SUPPLEMENT 2

Gadsden K8 School

Allstate Construction, Inc.

Quincy K-8 School
Changes to Drawings & Specs
Allstate Construction, Inc.
10-29-2025 (new items are in purple-colored text)
~~10-17-2025~~ (previous items remain in black-colored text)

A-115

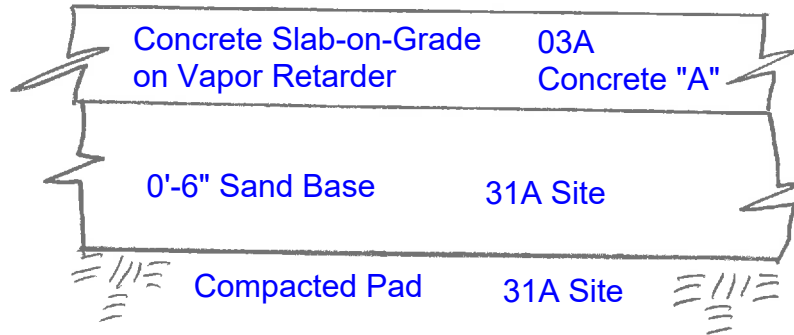
6. Add tag for Door No. C175B (A-115).

Z-08 Capillary Base at Slabs-on-Grade
Allstate Construction, Inc.
10-29-2025

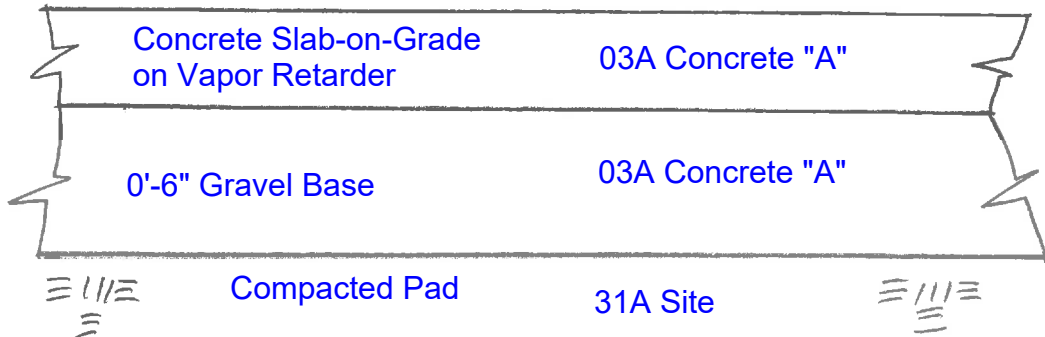
3. The following Contractor Sketch (dated 10/29/2025) have been added.
 - Z-08 Capillary Base at Slabs-on-Grade

Base Price - Sand Base at Slabs-on-Grade

Alternate Price - Gravel Base at Slabs-on-Grade
